November 29, 2010

Re: Five Year Building Envelope Warranty Review

"Aqua at the Park" - 550 Pacific Street, Vancouver, BC

Item 2a Five year building envelope warranty review

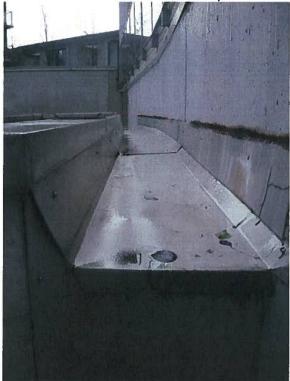
Item/ Photo			Corrective Action
2a 2b	Podium level	Discolored sealant between reglet flashing and concrete wall.	Remove and replace sealant as required

Item 3a Five year building envelope warranty review

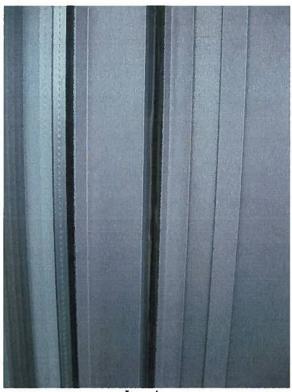
Item/ Photo	Sample Location	Deficiency Description	Corrective Action
3a 3b	805 1705 2208	Misaligned balcony swing doors. Doors do not lock and when closed, the perimeter gaskets are not fully compressed.	We note that doors may be improperly hung and should be adjusted.
		The owner of suite 805 states during the summer months, the door is most difficult to close.	_
4a 4b	805 1705	Sealant adhesion failure at the inside corner cap between the window wall and the balcony swing door.	Remove and reseal the corner cap.
5	2605	Paint stains on window wall frame at balcony.	This is an aesthetic issue and will not affect the building performance. Remove paint from frame.

Item 8a Five year building envelope warranty review

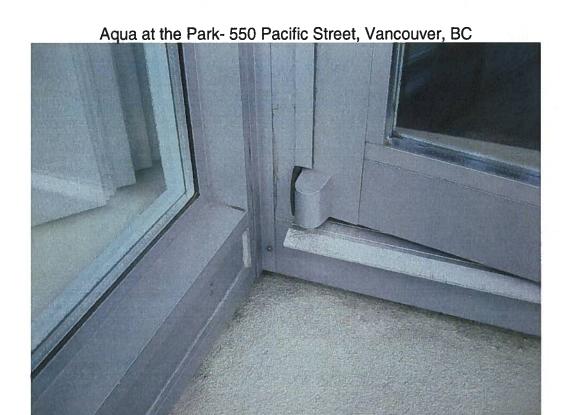
- the balcony sliding door is difficult to close and requires adjustment.	
7	307	Window description sticker on opaque panel adjacent to balcony door.	Remove window description sticker from opaque panel.
8a 8b	307 1205	Visible rubber gasket at side jamb of balcony door.	Realign rubber gaskets where required.
9	307	Balcony door65 handle loose and door does not lock.	Adjust door handle and replace defective hardware.
10	2208	Owner states there is a cold draft coming from living room windows.	Ensure window operables are fully latched top and bottom. Further review may be required to determine source of draft.
11	2208	We observed a stain on the living room ceiling. Owner confirmed they have not seen any moisture around the staining.	Further review is required to determine the source of the stain. This appears to be an internal source of moisture.
12	Podium level	Exposed self-adhesive membrane below the door threshold.	Protect the exposed self-adhesive membrane from U.V. degradation. This can be done with metal flashing.

Item 14a Five year building envelope warranty review

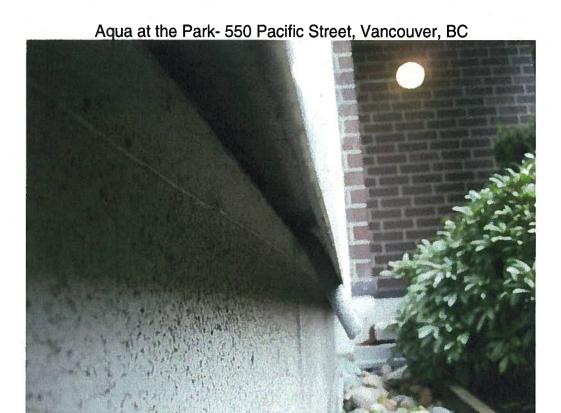
Item/ Photo	Sample Location	Deficiency Description	Corrective Action	
13a 13b	Podium level	Missing sealant at joint between brick assembly and metal flashing. We note a vertical sealant joint on the other end of the brick.	Install sealant between dissimilar assemblies.	
14a 14b	Podium level	Foam backer rod visible below window sill metal flashing.	Trim backer rod where exposed.	
15	Podium level, outside of TH	Inconsistent sealant installation between structural shelf-angle and brick.	Install sealant between shelf angle and top of brick.	
16	Deck outside	Broken tile at the edge of the deck, outside of the pool.	Replace broken tile.	
	of pool	At the same location, we observed the sealant was stained.	Remove and replace sealant as required.	
17	Podium level, outside of TH	Algae stain on surface of exterior planter wall and surface of brick.	Remove algae stains from top of planter walls and from surface of brick as part of regular maintenance.

Item 19

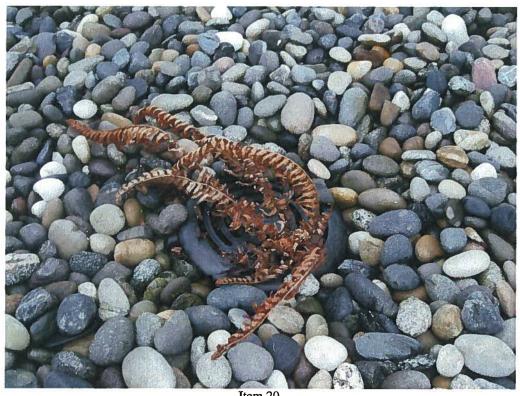
18a 18b	Typical	Algae stain at edge of slab and on balcony surface.	Remove algae stains from concrete as part of regular maintenance.	
19	Typical	Lint observed in dryer vents.	Clean vents as part of regular maintenance.	
20	Mech. Rm. roof	Vegetation obstructing the roof drain screen.	Remove vegetation from roof drain screens to ensure free drainage.	
21	21 Mech rm roof We note the bottom of the roof drain pipe is directly on the roof ballast. At the same location, we observed the sealant at the base of wall flashing is discolored.		We recommend installing a splash pad (i.e. paver) below the drain	
			Remove and replace sealant as required.	
22	Main roof canopy	We note the top of the concrete surface at the canopy above the roof access door was stained. The concrete appears to be coated.	Clean concrete surface as part of regular maintenance.	
23	Main roof	Dislodged mechanical louver.	Reinstate mechanical louver.
